MONITORING YEAR 2 ANNUAL REPORT FINAL

HUNTSMAN MITIGATION SITE

DMS Project No. 100123
DMS Contract No. 7891
DMS RFP No. 16-007728; Date of Issue: 11/13/2018
USACE Action ID No. SAW-2019-00836
DWR Project No. 20190866
Data Collection Dates: February - November 2023
Submission Date: January 2024

RE: Huntsman Draft MY2 Report Review
Yadkin River Basin – CU# 03040102
Wilkes County
DMS Project ID No. 100123
Contract # 7891

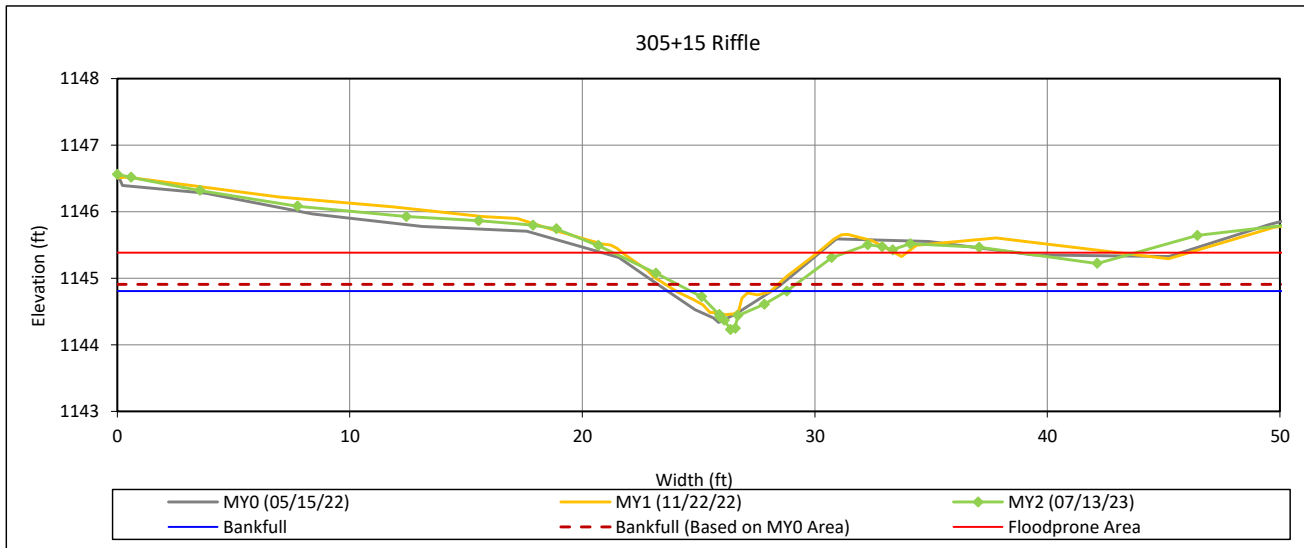
DMS' Comment: Section 2.3 contains a short discussion regarding the isolated bed scour at XS10 and the resulting BHR of 1.3. It should also be noted that when the BHR is calculated using the AB bankfull area, the BHR is 1.0 as shown on Table 10.

Wildlands' Response: The BHR for XS10 was misreported on Table 10. The correct BHR is 1.3, and Table 10 has been updated accordingly.
